# Access Compliance Report

## Public Rights-of-Way

Intersection ID: 8835	Main Street: BRADFORD_DR	Cross Street: NORTH_AV	Location: SE
ADA ID: 5C9675B3033D	Ramp Type: Perp	Initial Pass/Fail: Fail	Overall Compliance: No
		Severity Score: 50

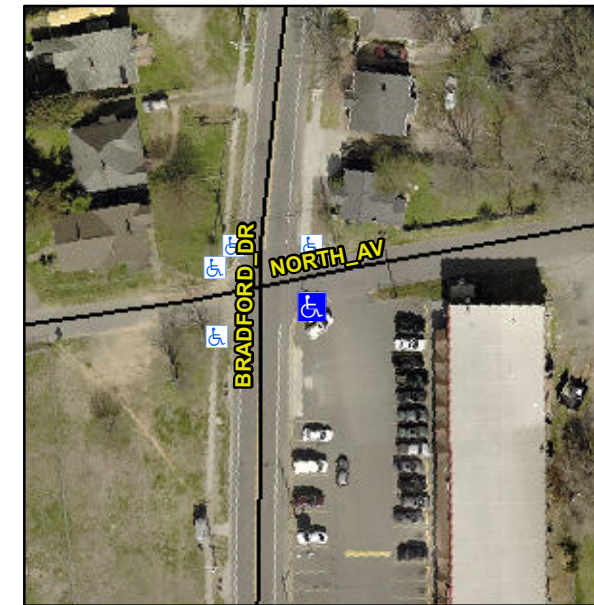
**Not Found, R304.2.2, R304.5.3**

Compliance	Description	Data	Compliance	Description	Data
N/A	Ramp Length (in)	73.0	No	Ramp Slope (%)	14.3
Yes	Ramp Width (in)	48.0	No	Ramp XSlope (%)	7.2
N/A	Flare Type LT	N/A	N/A	Flare Type RT	N/A
N/A	Flare Slope LT (%)	N/A	N/A	Flare Slope RT (%)	N/A
N/A	Flare Traversable LT?	N/A	N/A	Flare Traversable RT?	N/A
N/A	Landing Length (in)	N/A	N/A	DWS Provided?	N/A
N/A	Landing Width (in)	N/A	N/A	DWS Contrast?	N/A
N/A	Landing Slope (%)	N/A	N/A	DWS Length (in)	N/A
N/A	Landing X Slope (%)	N/A	N/A	DWS Full Width?	N/A
N/A	Landing Curb? (Y/N)	N/A	N/A	DWS Offset (in)	N/A
N/A	Shared Landing?	N/A			
N/A	Gutter Ponding?	N/A	N/A	Gutter Slope (%)	N/A
N/A	Gutter Lip Ht (in)	N/A	N/A	Gutter X Slope (%)	N/A
N/A	Painted X Walk1?	No	N/A	Painted X Walk2?	N/A
	X Walk 1 Direction	To N		X Walk 2 Direction	N/A
N/A	X Walk 1 Width (in)	N/A	N/A	X Walk 2 Width (in)	N/A
	X Walk 1 Slope (%)	4.9		X Walk 2 Slope (%)	N/A
	X Walk 1 X Slope (%)	8.8		X Walk 2 X Slope (%)	N/A

**Remove & Replace Entire Ramp.**
